SQ Celsius Limited (Unit 2)

Jamirdia, Bhaluka, Mymensingh
(24.2849521N, 90.3946713E)
11th November 2018

Observations

New shear wall construction layout

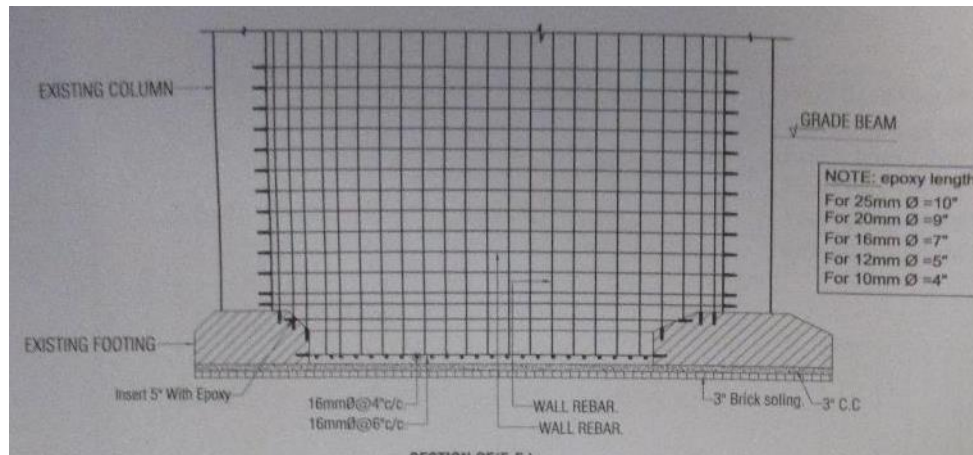
New shear wall is being constructed by top to bottom method

Rebar connection detail of new shear wall with existing columns

Three new shear walls were proposed in the structure drawing for improving the lateral stability of the building. Among them, one shear wall is being constructed by top to bottom method. The design report is required to evaluate by ACCORD for assessing the advisability of the shear walls.

Implement floor load management program

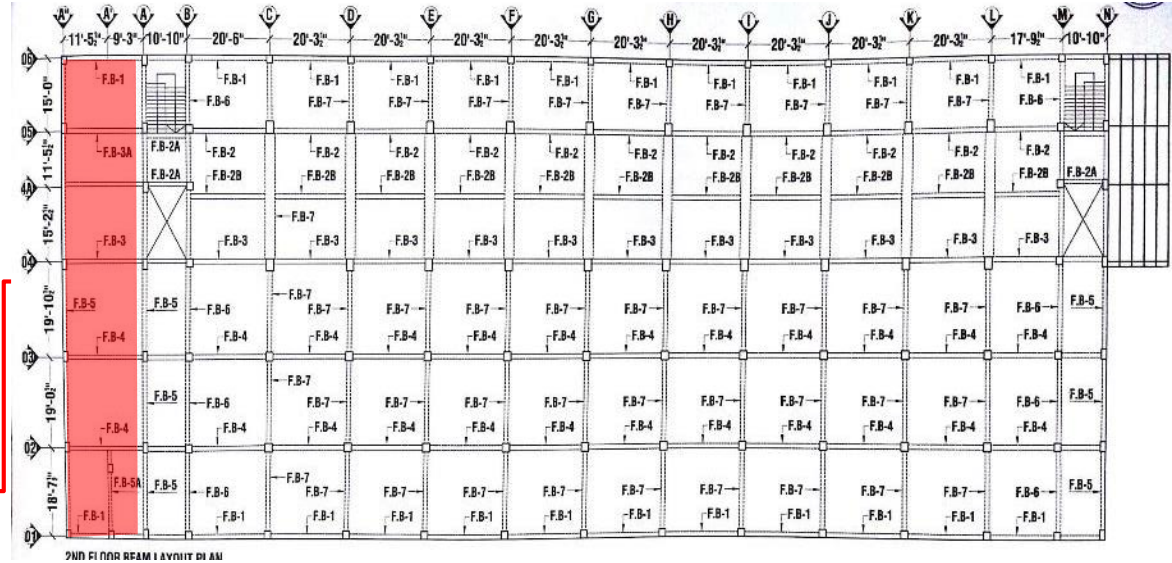
Load plan with load marking was visible on store area on 1st and 2nd floor. Factory is required to implement load management program as per its floor loading capacity. The load plans for all floors of the buildings must be maintained and the workers must understand the loading requirements.
